REFERENCE XXX-EQCOD-EC-XXXX

Date: 2017-05-03

ENGINEERING CHANGE REQUEST

WP11: 11 T DIPOLE FULL ASSEMBLY POINT 7

Figure 1 — Picture of area under change, 8.L7 at R72 – present MB.B8L7

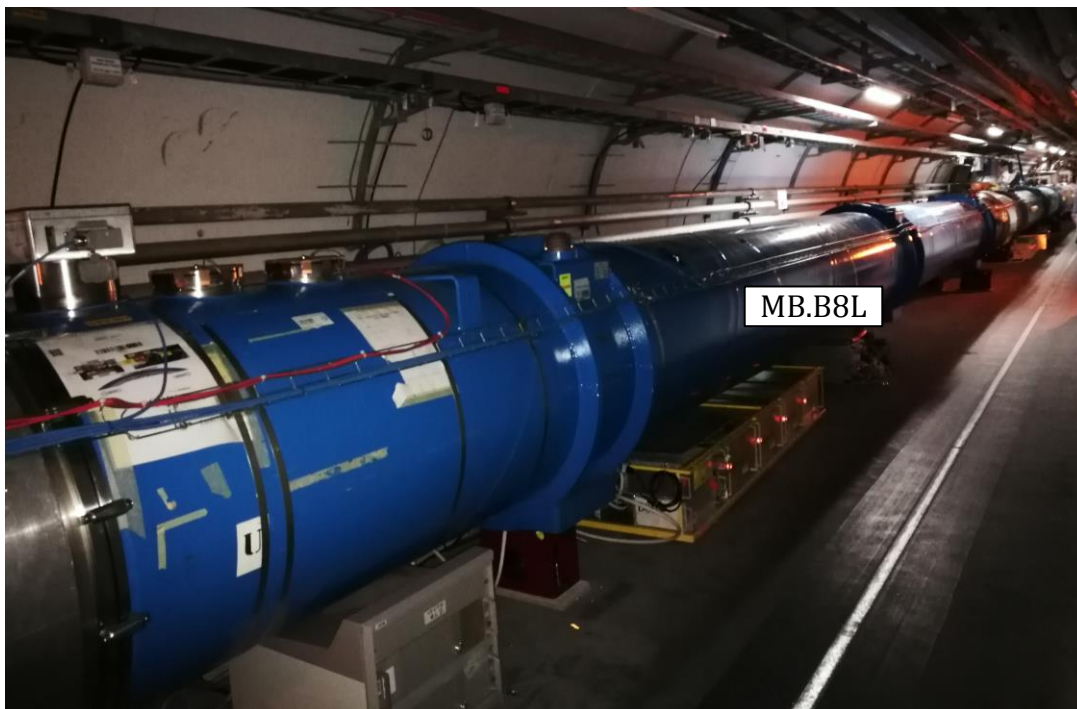
The present state of the concerned areas is shown in Figures 1 and 2.

It is foreseen to exchange the following two MBs:

- **MB.B8L7** (LBARA.8L7)
- **MB.B8R7** (LBBRB.8R7)

Figure 4: Section of HL-LHC layout for P7 left (from LHCLSSH_0013) – New components

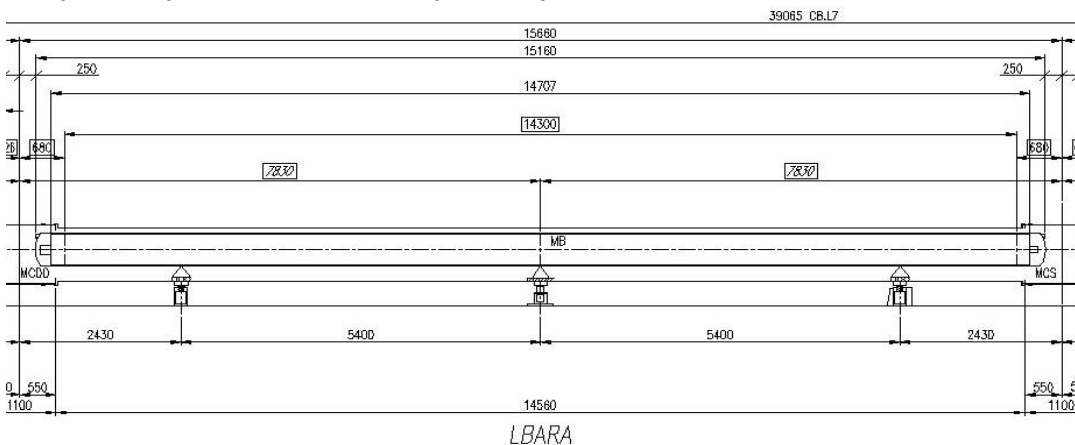
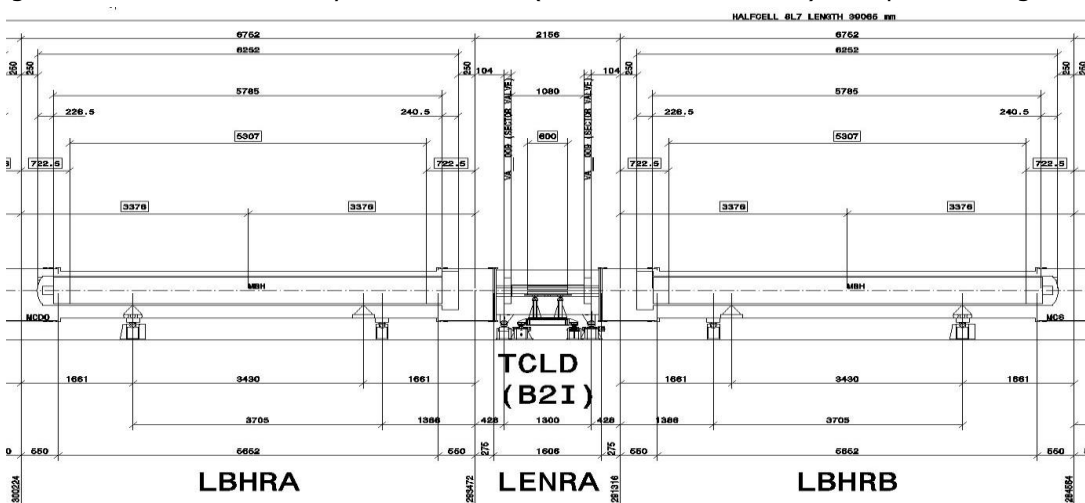
- Removal of the present main dipole **MB.B8L7** (LBARA.8L7, circuit RB.A67)
- Installation of the 11T dipole full assembly at the MB place. The assembly is composed of two dipoles of equal bending strength and shorter magnetic

- After that, installation of a new TCLD collimator between the two magnets, on the beam line 2 (internal beam, or passage side) will follow.

Layout drawings LHCLSS__0029/LHCLSS__0030 (LHC layout for the DS region at point 7) and LHCLSSH_0013/LHCLSSH_0014 (HL-LHC layout for the same zones) show the changes induced by the implementation of the TCLD collimator and the two short 11T dipoles where there was one 8.33T/14.3m long dipole magnet on each side of P7. Figures 3 and 4 show as an example the section of the LHC layout for P7 left before and after the change.

Figure 3. Main dipole circuit RB.A67 configuration for the HL-LHC with the 11T trim power converter.

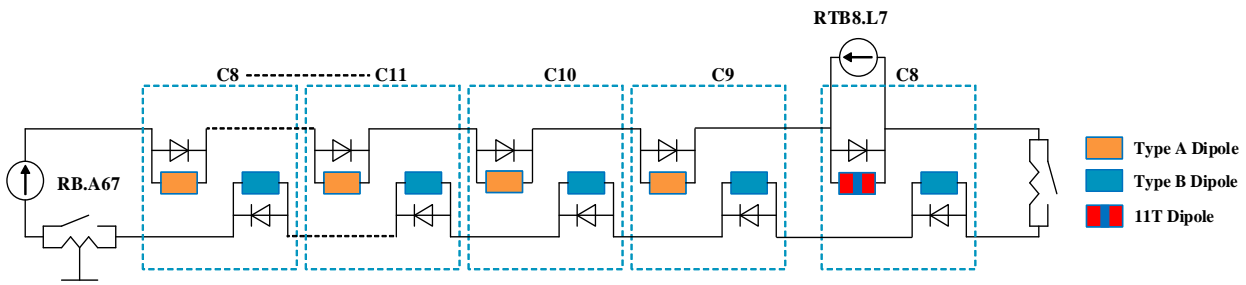
The modified circuit layout of RB.A67 (with trim circuit **RTB8.L7**) and RB.A78 (with trim circuit **RTB8.R7**) is shown in Figure 3 and 4. A detailed description of the circuits is provided in [8], Section 2.1-2.7. The RB circuit characteristics before and after the change are summarized in Table 5. For the circuit RB.A78 the 11 T dipole full assembly

will be placed after the second energy extraction system, creating a little dissymmetry in the RB circuit.

Figure 5. Location of the new DYPB for the 11T dipoles.

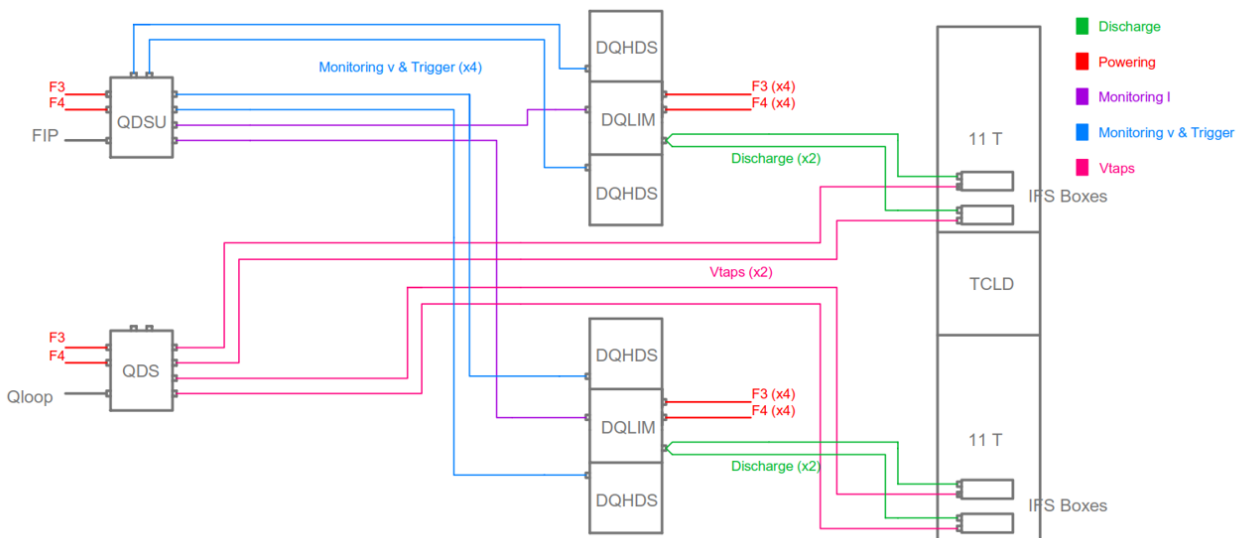
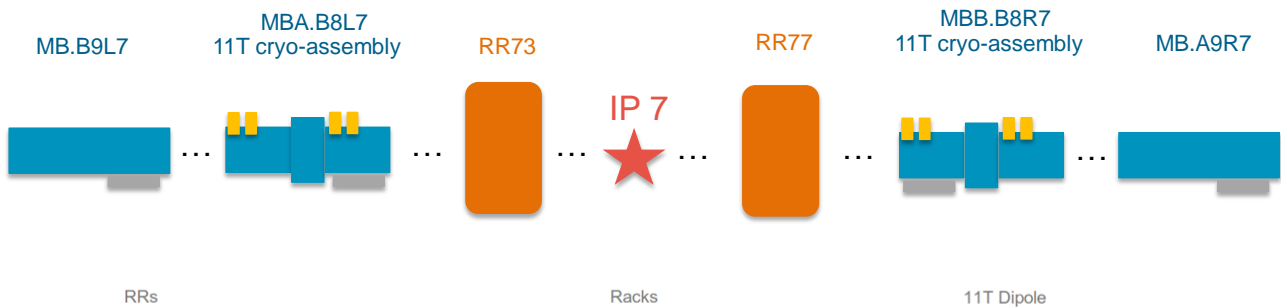
The non-standard QPS racks will be placed at (see the grey boxes in Figure 5):

- L7: 1 rack under 11T dipole + 1 rack under MB.B9L7;
- R7: 1 rack under 11T dipole + 1 rack under MB.A9R7.

Four new racks will be installed in the machine. One spare unit will be manufactured.

Figure 6. Relocation of the DYPQ that needs to be moved due to the high radiation doses.

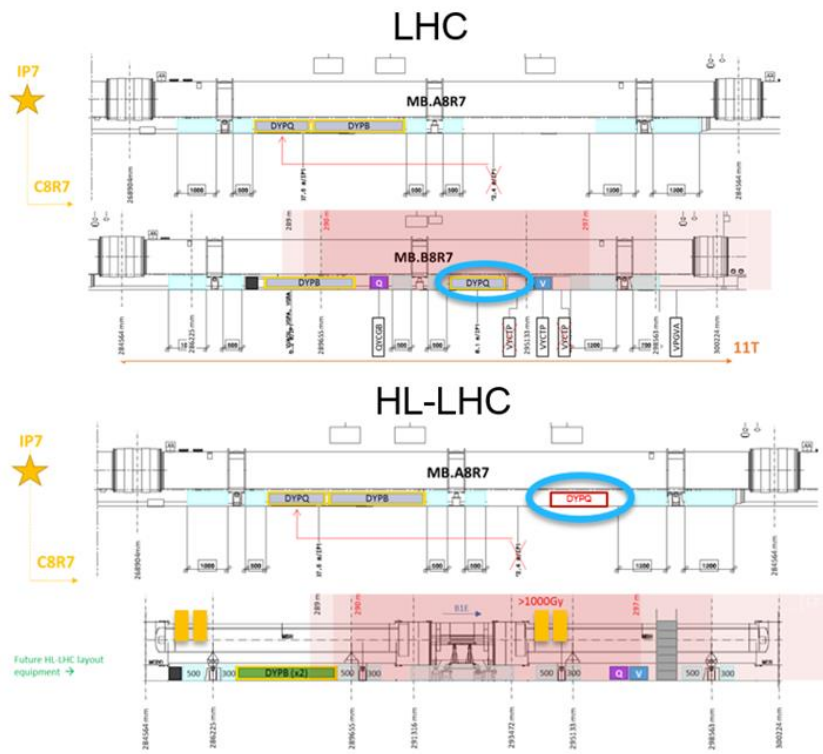
Moreover, there is today a DYPQ rack located under MB.B8R7 that will be moved under MB.A8R7. This requires consequently new cabling between the quadrupole cryostat and the new position of the rack. See Fig. 6.
